Network Video Recorder

Version: V4.50.000 build210125

Release Note

Firmware Basic Information	Firmware Version:	V4.50.000 build210125
	SDK Version:	V6.1.6.5_build20201028
	Play Library:	V6.0.0.5
	Web component:	V4.0.1.1build201209
	OpenSDK Version:	V2.1.4

1. 【Local GUI menu operation optimization】

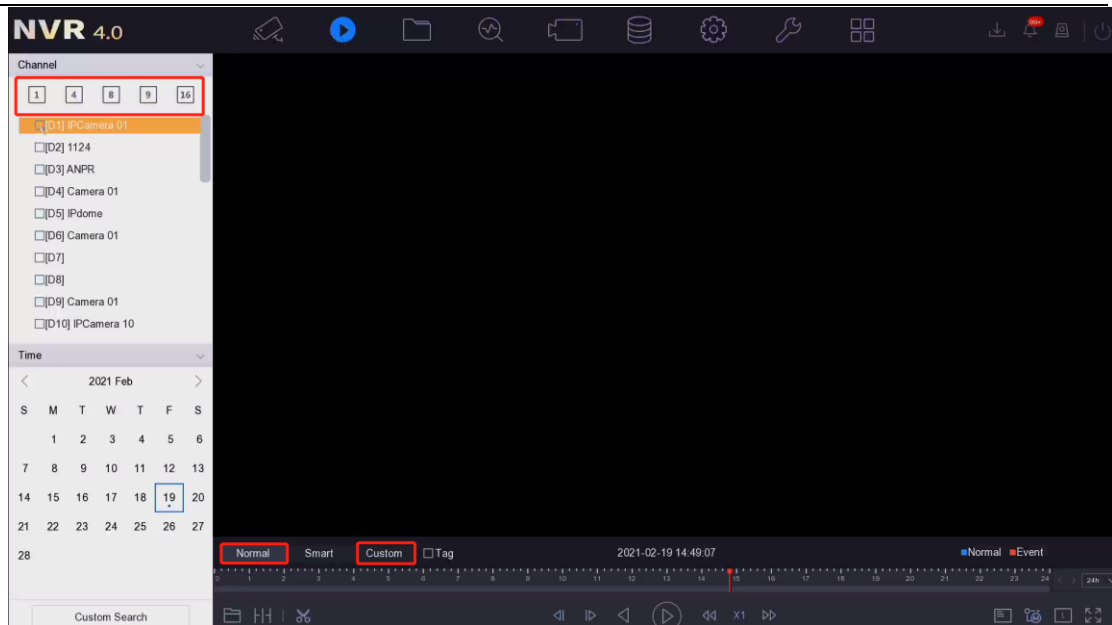
- 1) Local Live View supports shortcut operation of right-click menu. The specific menu options are: Single-screen selection; Multi-screen selection; Previous screen; Next screen; Start/stop Auto-switch; Add IP channel; Playback; PTZ control; Full screen/Main menu

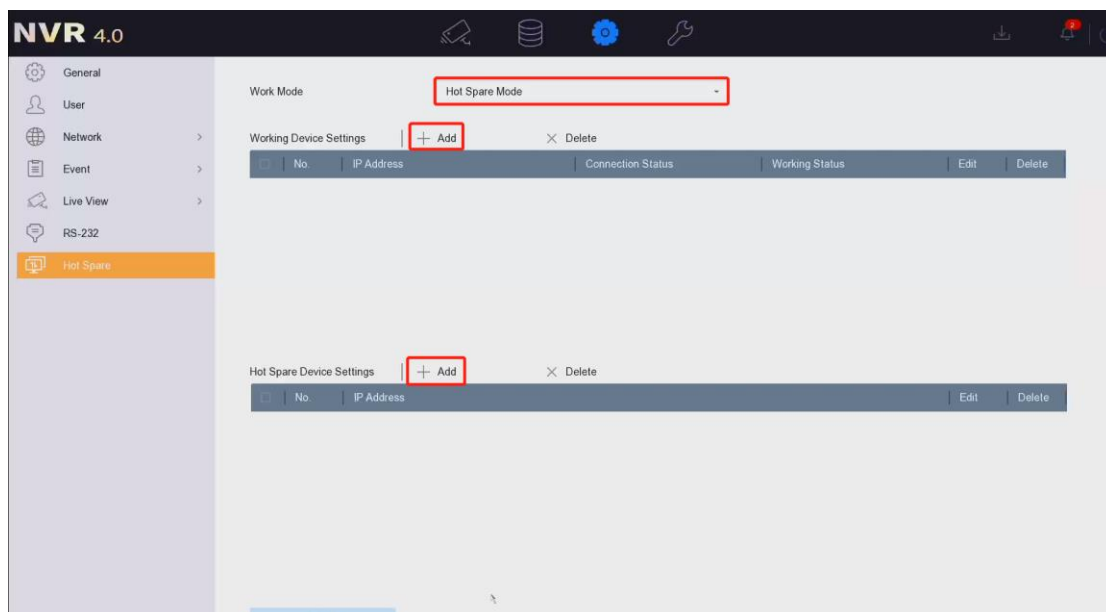
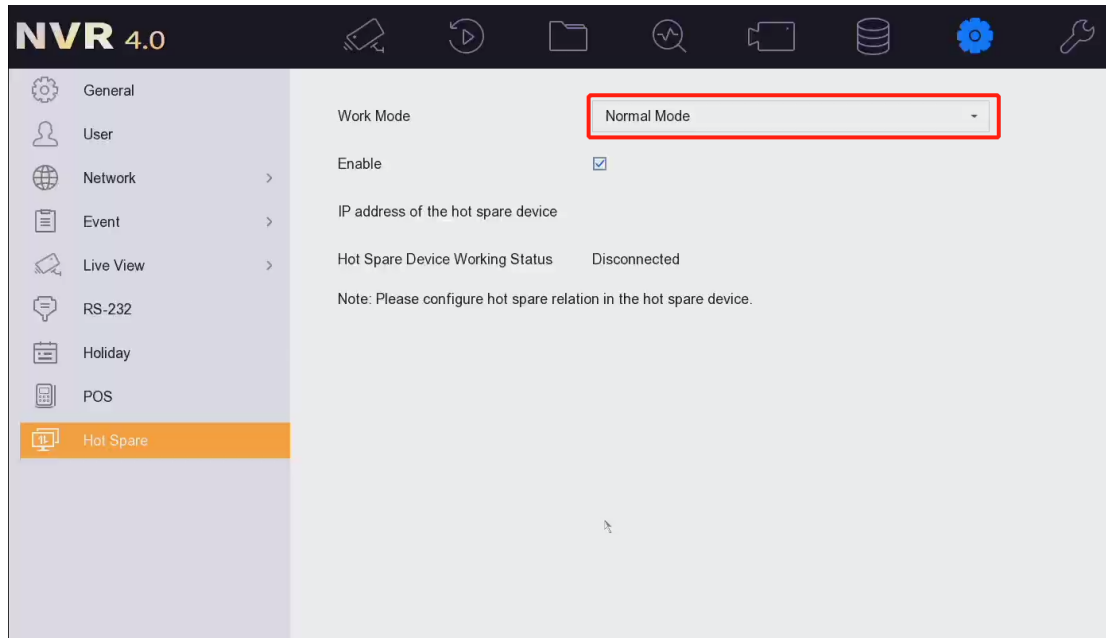
- 2) Local normal playback and custom playback support channel group selection function.

- 3) The progress bar supports mouse wheel control when playing back video, and the left mouse button is used for positioning.

- 4) Remove the double progress bar, the progress bar only displays the video distribution of the currently selected channel.

2. 【N+M function】

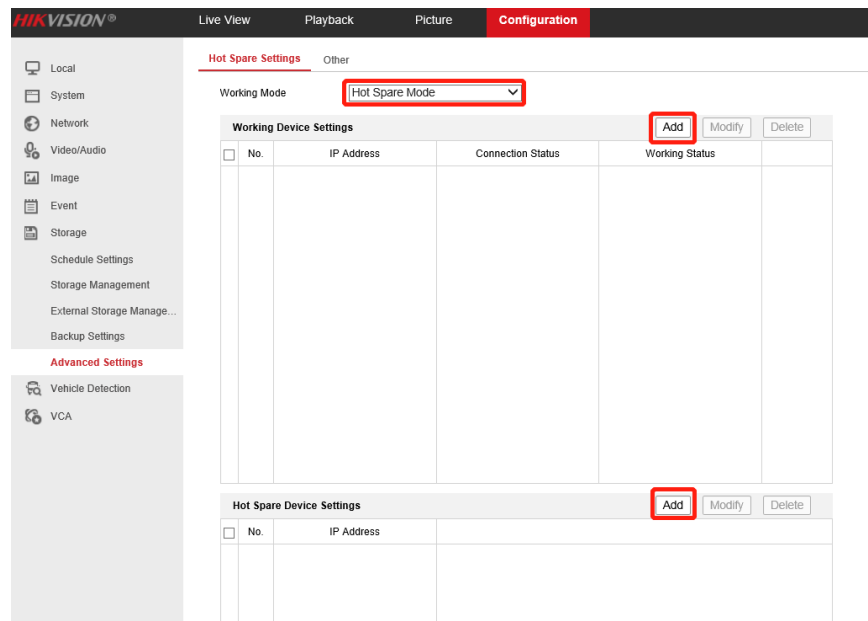
- 1) N+M system hot backup is to solve the scenario where multiple working machines fail at the same time, it supports adding up to 32 working machines and 32 hot backup machines.
- 2) The hot standby NVR can automatically take over the offline working machine, and return the video after the working machine is restored.

- 3) Compatible with the original N+1 function, the original local N+1 configuration menu is modified to the N+M configuration menu, the N+M menu is added on the WEB, and only the N+1 configuration menu is retained on the 4200.
- 4) On the basis of the existing N+1 environment, other hot standby machines can be added to the hot standby machine to form an N+M system.

4. 【ISUP protocol supports stream encryption function】

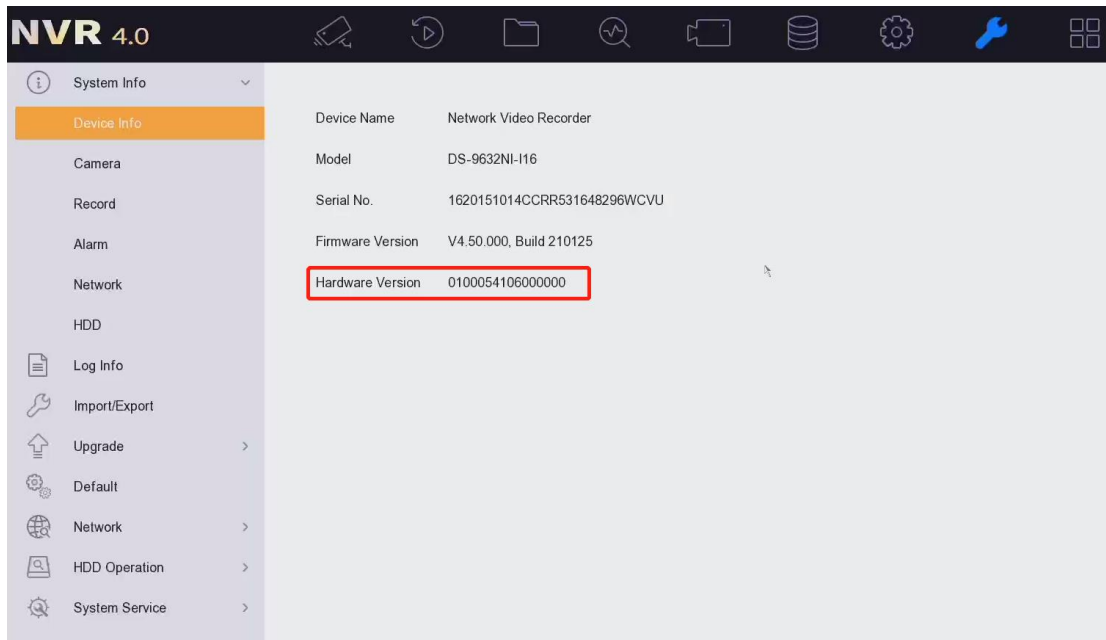
In order to improve the security of data information, ISUP protocol supports TCP, smooth streaming stream encryption transmission and voice intercom data encryption.

6. 【Add the hardware version number on the local GUI】

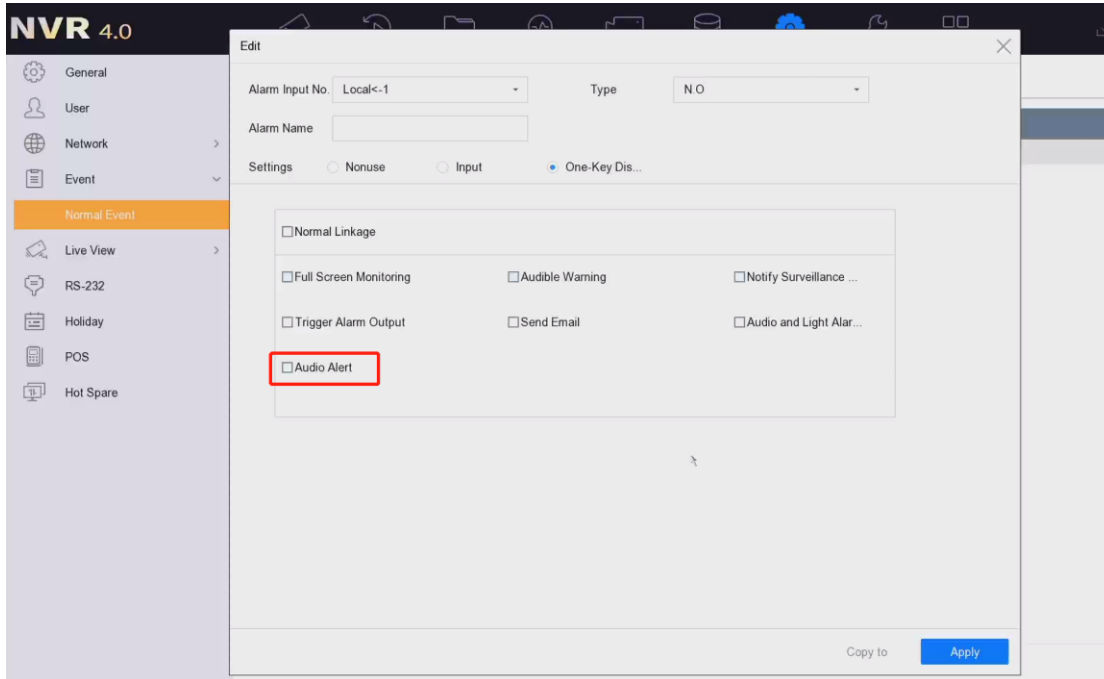
The local GUI adds the hardware version number to distinguish the devices of the same model with different motherboards.

1. 【Multi-track stream ultra HD resolution camera access optimization】

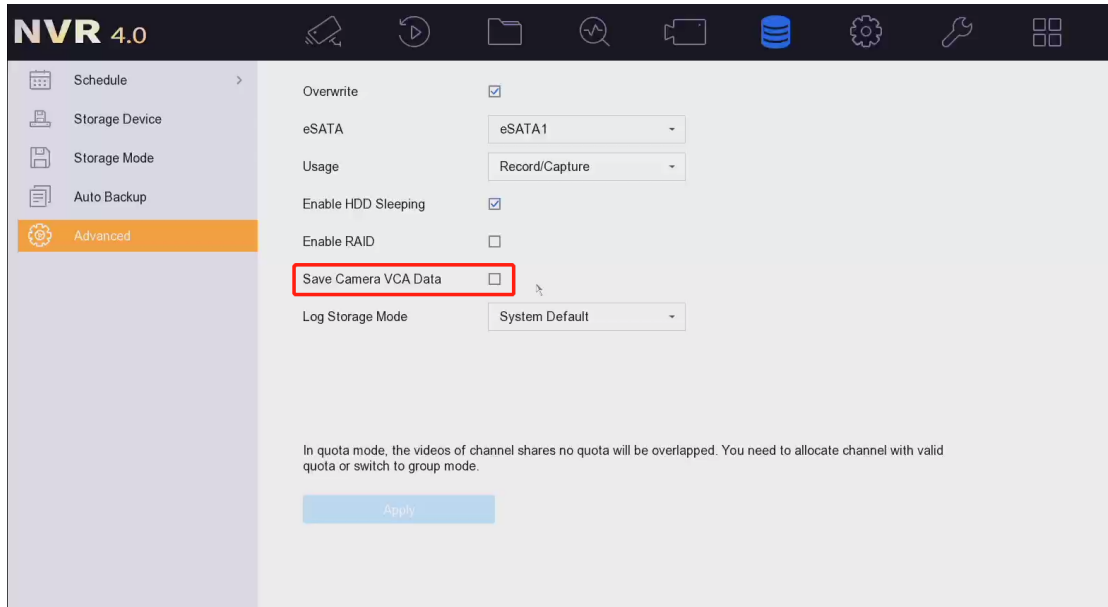
- 1) Maximum support for multi-track streaming and ultra HD resolution cameras to connect to any 4 channels of NVR.
- 2) The maximum resolution of high-resolution cameras that support single-track streaming is 4096*4096.
